## 2015 - 2016 Corvette: Service Bulletin: #16-NA-014: Delayed Engagement After Sitting With Engine Off

# #16-NA-014: Delayed Engagement After Sitting With Engine Off - (Jun 28, 2016)

**Subject:** Delayed Engagement After Sitting With Engine Off

(A)Old stator support asm  
(B)New stator support asm

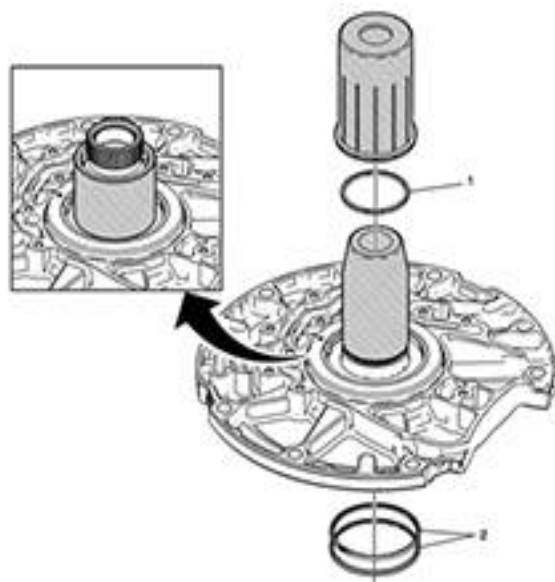
**Note:** The new stator shaft support assembly has a second check ball (1) added (see illustrations).

Install a new stator shaft support assembly that includes an additional check ball. Follow the instructions below to replace the stator shaft support assembly.

(A) Old cover - 8L90 Only

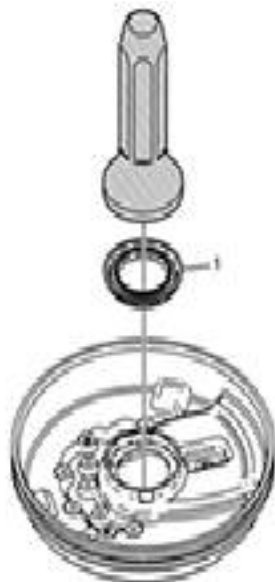
**Note:** The casting void has been eliminated from the underside of the cover for the 8L90 only (see illustration). The 8L45 is not required.
